Plan change number: Plan Change 94  
Plan change name: PC 94 (Private): Wairaka Precinct

## **Submission by The Tree Council on Plan Change 94 Te Auaunga Precinct**

Submission to Auckland Council: Proposed Plan Change 94 – Wairaka/Te Auaunga Precinct, private plan change by the Ministry of HUD

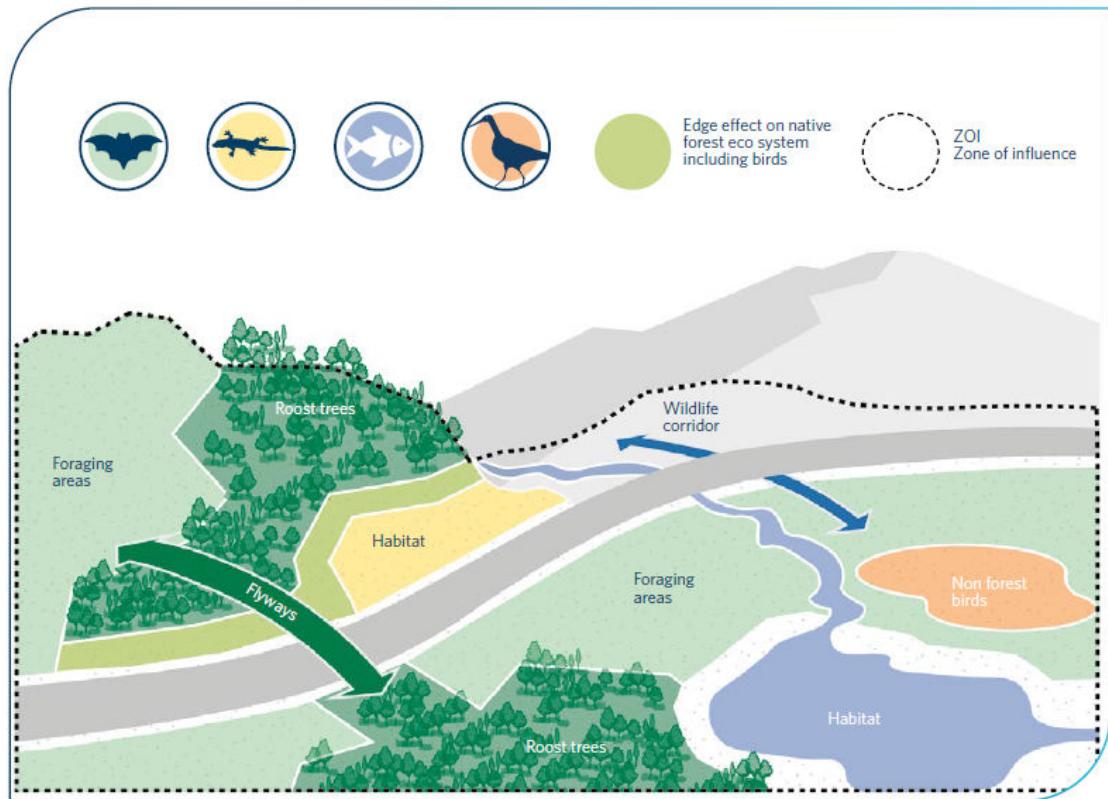
14.16 The statement is incorrect. The Great North RD interchange is not a separation in ecological terms (ref to the simple NZTA leaflet in LV AEE considerations). The native planting surrounding the Great North Rd interchange is a coastal forest that connects marine and riparian ecosystems and are a mitigation measure of *SH20 Waterview connection*. It was considered highly effective mitigation in terms of plant associations, bird habitat, ecosystem connection among others.

Map 1: Zoning

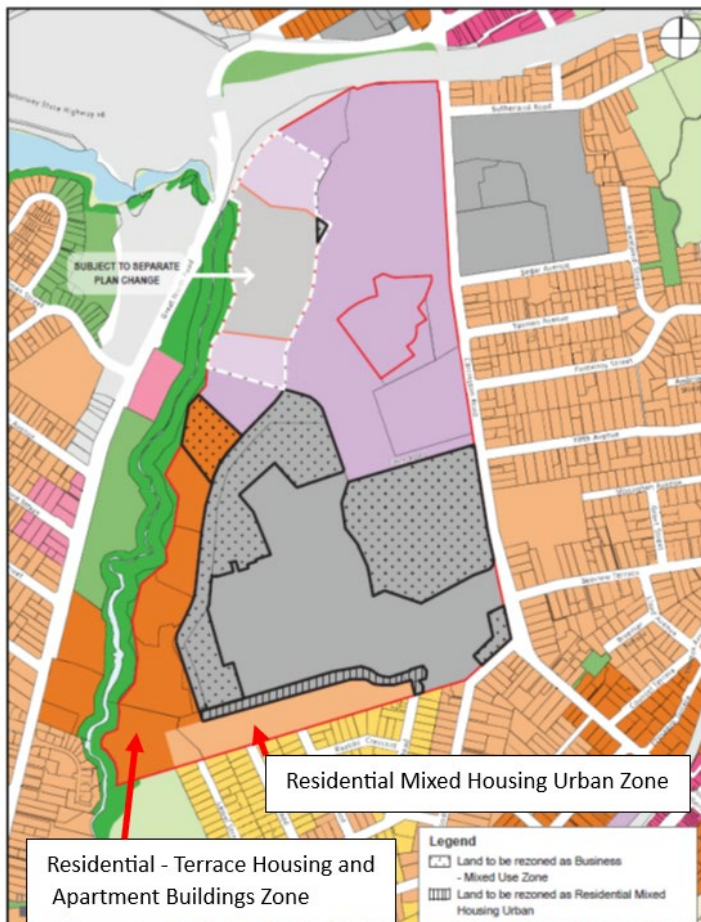
- The proposed precinct provisions relating to the Residential - Terrace Housing and Apartment Buildings and the Residential Mixed Housing Urban Zones, as shown in the Zoning Map 1 below.
